C Organizational Control of Emergencies

This section of the Plan describes the organizations required by the Station during a declared emergency, as well as the organizations required for daily operation.

**Table C-1 Minimum Staffing Requirements (STPEGS) (Including Capability for Additional Staffing)
(Page 1 of 3)**

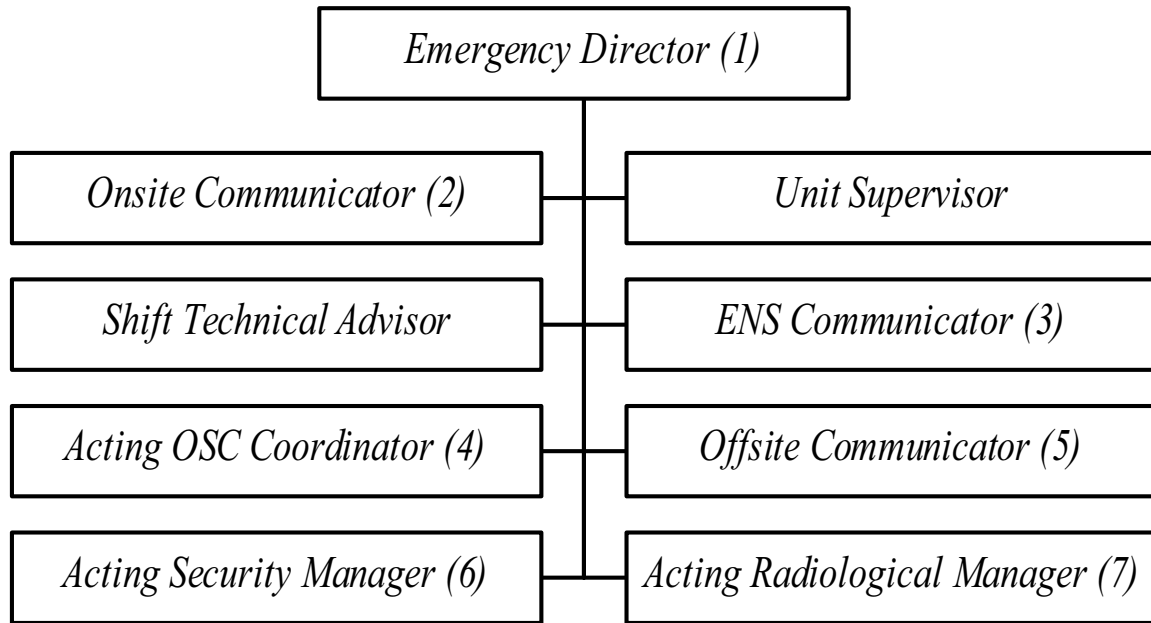
**~~Table C-1 Minimum Staffing Requirements (STPEGS)
(Including Capability for Additional Staffing)
(Page 1 of 3)~~**

**~~Table C-1 Minimum Staffing Requirements (STPEGS)
(Including Capability for Additional Staffing)
(Page 2 of 3)~~**

**~~Table C-1 Minimum Staffing Requirements (STPEGS)
(Including Capability for Additional Staffing)
(Page 3 of 3)~~**

Table C-1 Minimum Staffing Requirements (STPEGS) (Including Capability for Additional Staffing)
(Page 2 of 3)

**Table C-1 Minimum Staffing Requirements (STPEGS) (Including Capability for Additional Staffing)
(Page 3 of 3)**

Figure C-1 Onshift Emergency Response Organization

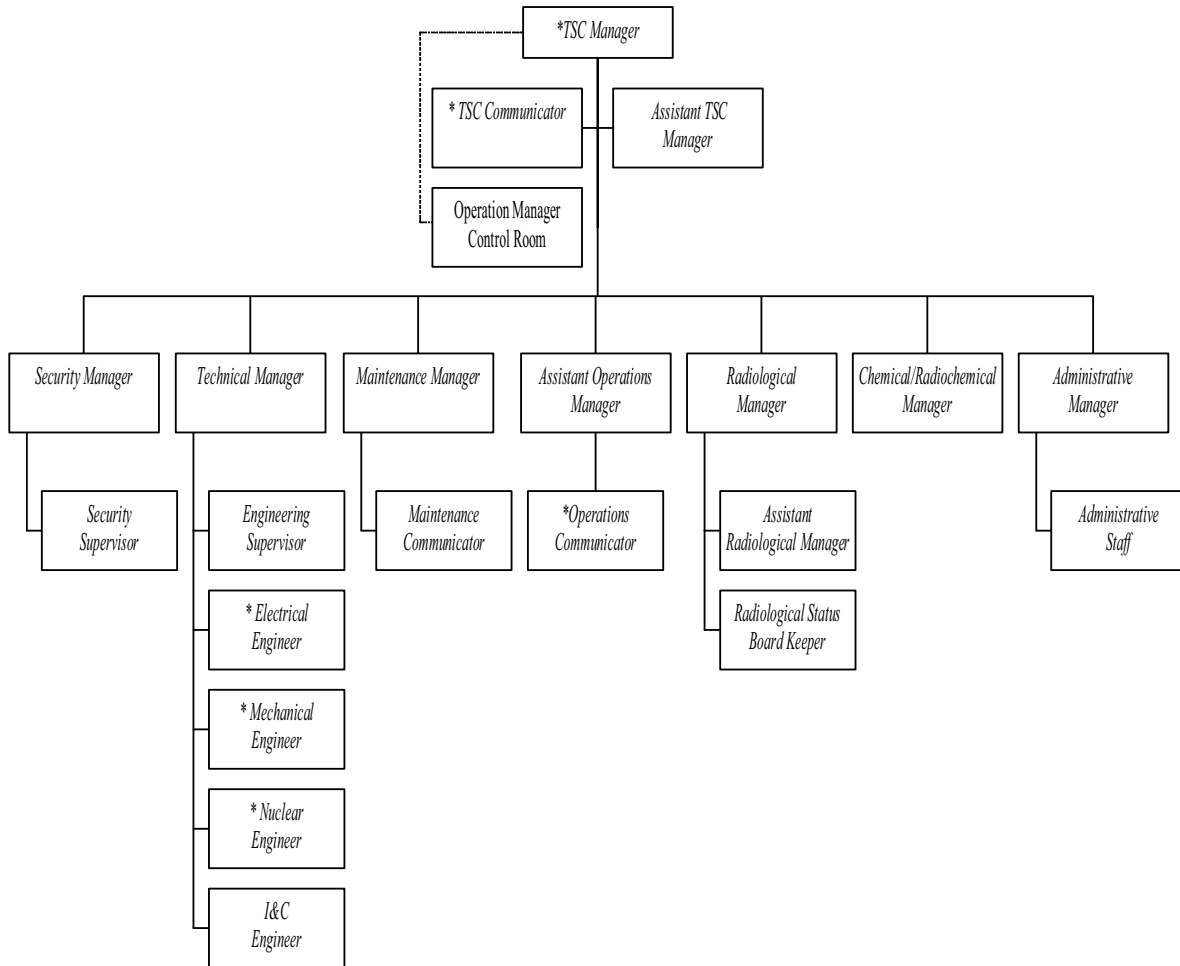
~~(1) Shift Supervisor; (2) Plant Protection; (3) Reactor Operator, currently or previously licensed by NRC, or SRO Management Certified Personnel; (4) Duty Maintenance Supervisor; (5) Plant Operator; (6) Security Force Supervisor; (7) Senior Radiation Technician.~~

~~() - Identifies onshift personnel position titles~~

(1) Shift Supervisor:

(2) Plant Protection

(3) Reactor Operator, currently or previously licensed by NRC, or SRO Management Certified Personnel

(4) Duty Maintenance Supervisor

(5) Plant Operator

(6) Security Force Supervisor

(7) Senior Radiation Protection Technician.
